City of Ramsey
Agenda
Regular Planning Commission
Thursday, January 4, 2018
7:00 pm
Council Chambers, 7550 Sunwood Drive NW

PUBLIC HEARING: Comprehensive Plan Amendment, Zoning Amendment, and Site Plan for Ramsey Elementary Campus 2 (Project #17-109)

Notes must only appear on one (1) sheet.
Text must not appear over other text or symbols, example detail reference 9A/C2.12 south of main entrance on sheet C1.31 is over a flared end symbol.
Break lines under text.
A cover sheet is required listing all of the sheets in the set.
Add notes to the plan set:
Hours of construction are 7:00 am to 10:00 pm. No equipment may be started before 7:00 am. Site work on Saturday requires 72 hour advance notice for approval. Sunday work requires City Council approval. Meetings are the 2nd and 4th Tuesdays. Requests must be submitted one week before for inclusion on the agenda.
These notes are summaries of the comments added to each page in ProjecDox.

SHEET NUMBER
C1.00

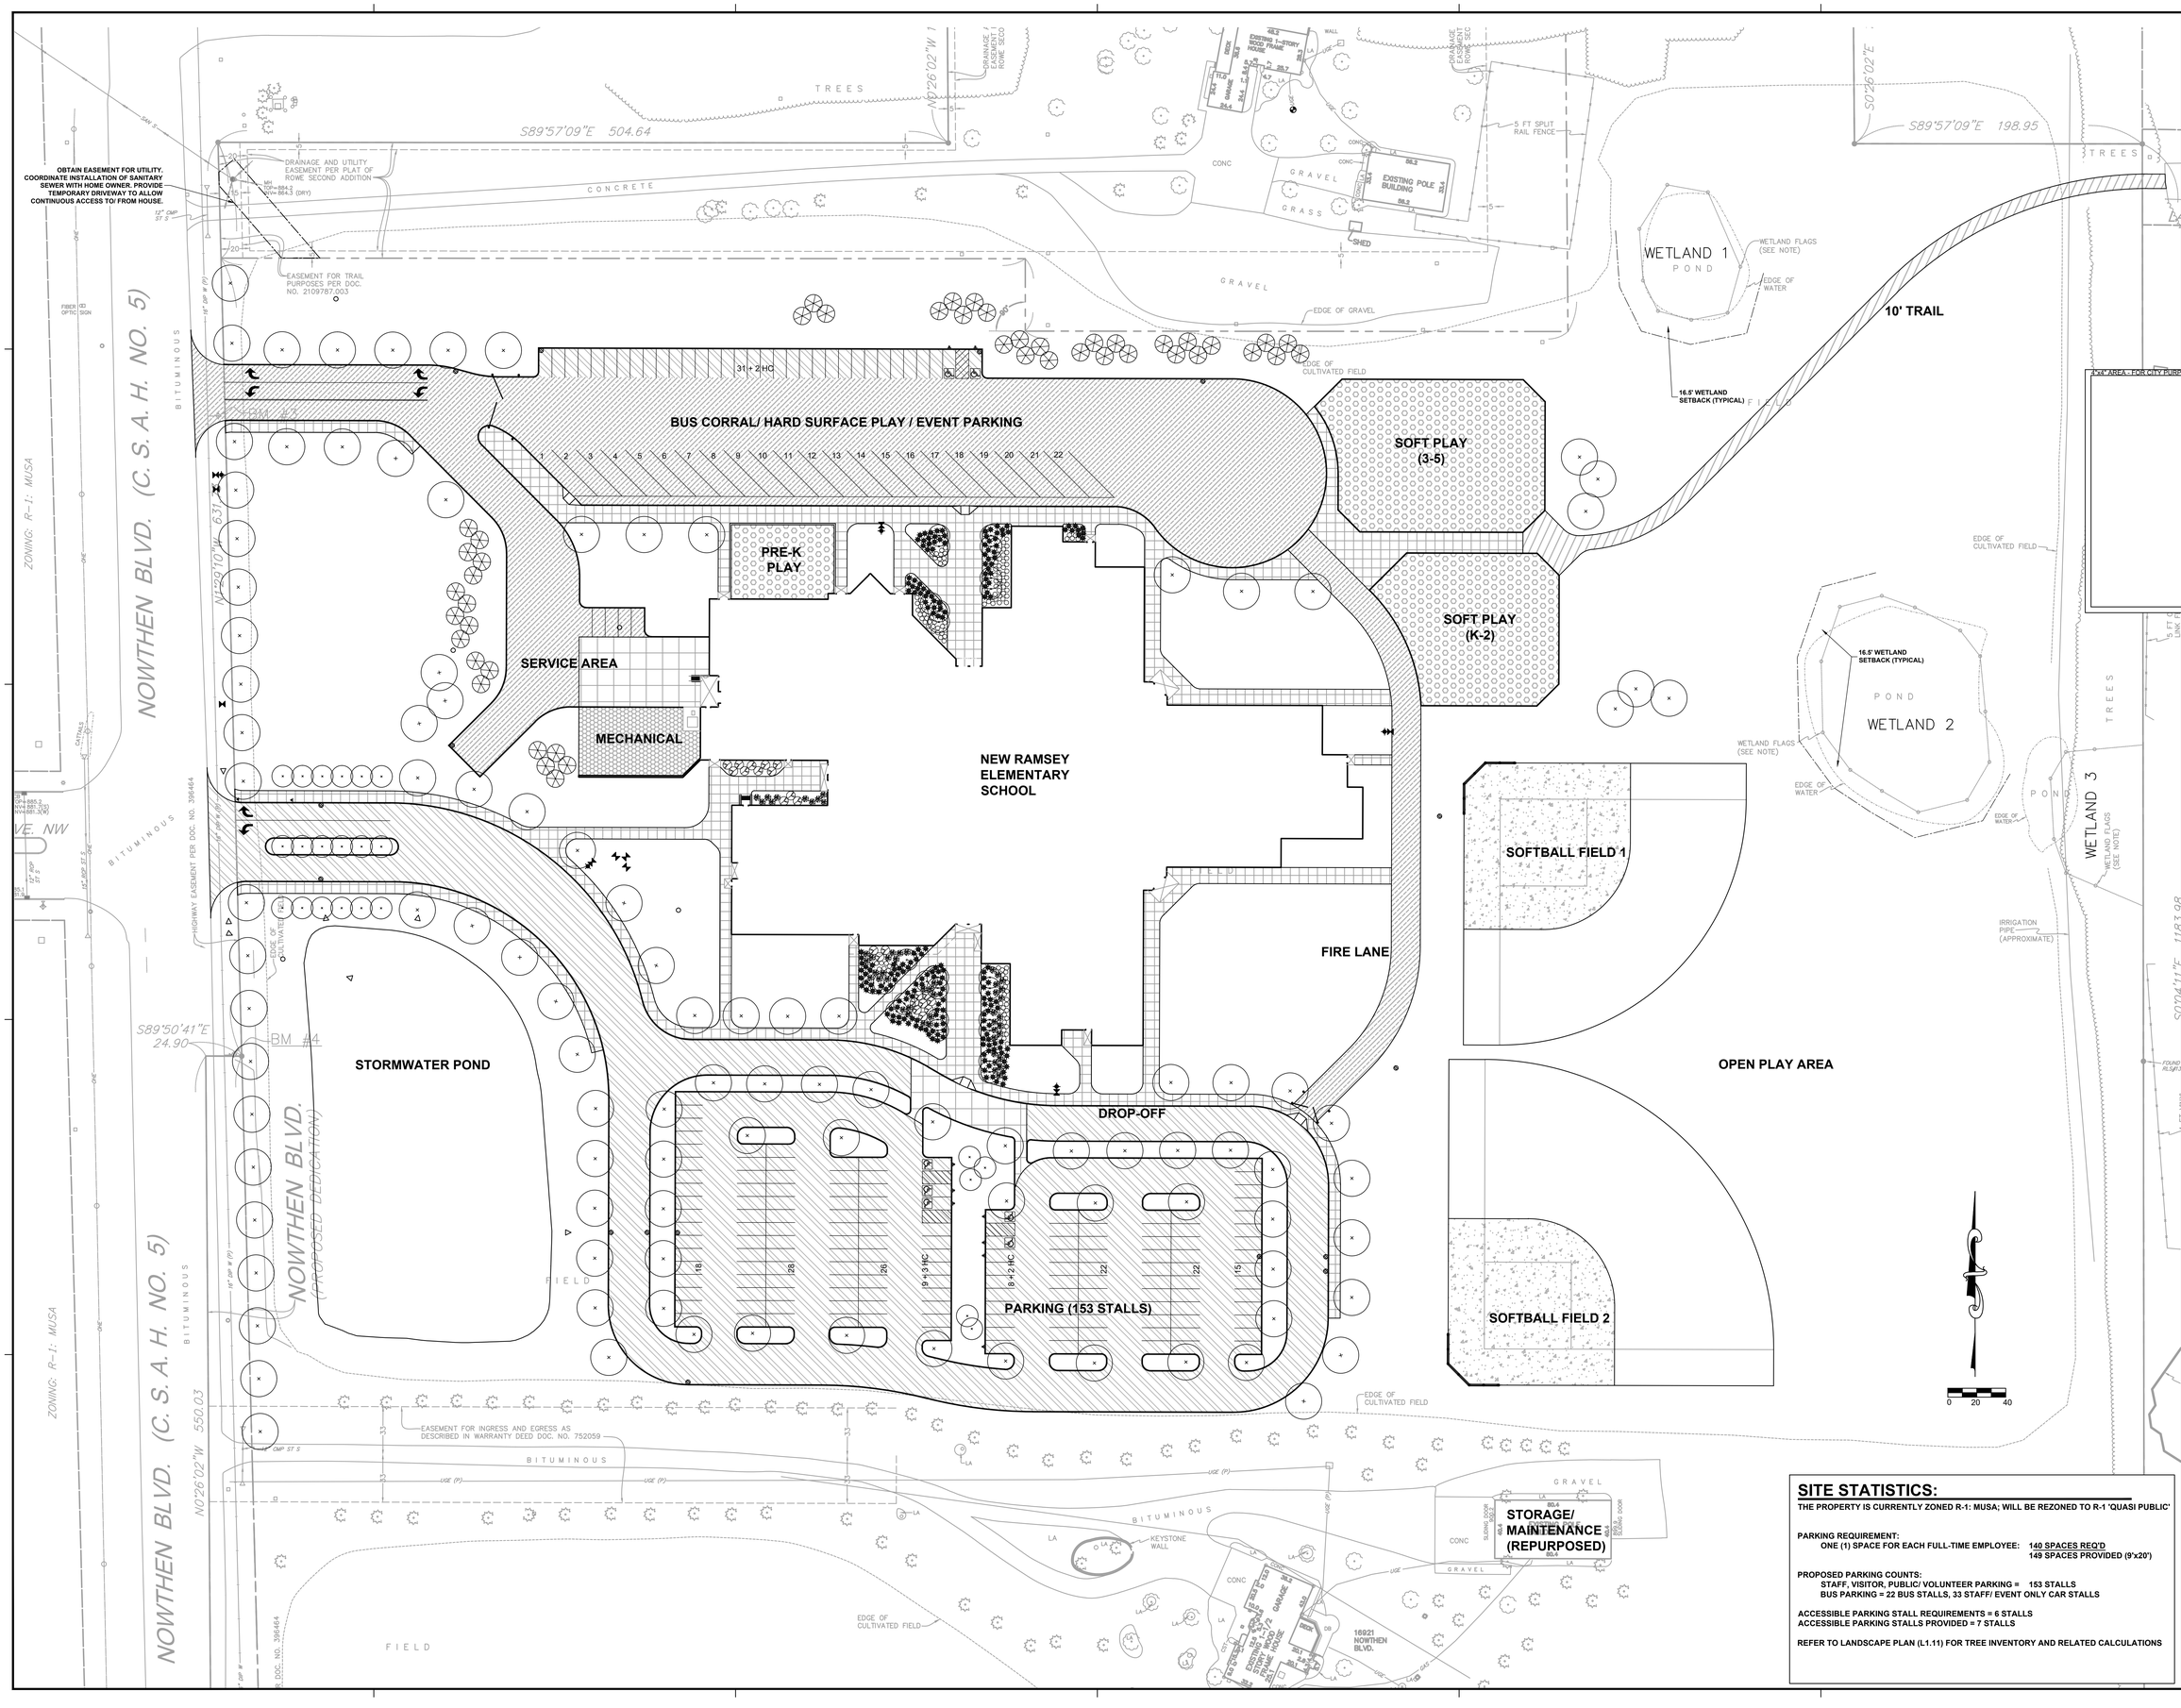
This is the removals sheet. Information on the removal of the existing house must be shown on this sheet.
The existing septic system must be removed and the well sealed.
The note about the drainage and utility easement for extending sanitary sewer must only appear on sheet C1.51.
All items removed must not appear on other sheets.
Sheet C1.40 is not in this sheet. Update the reference.
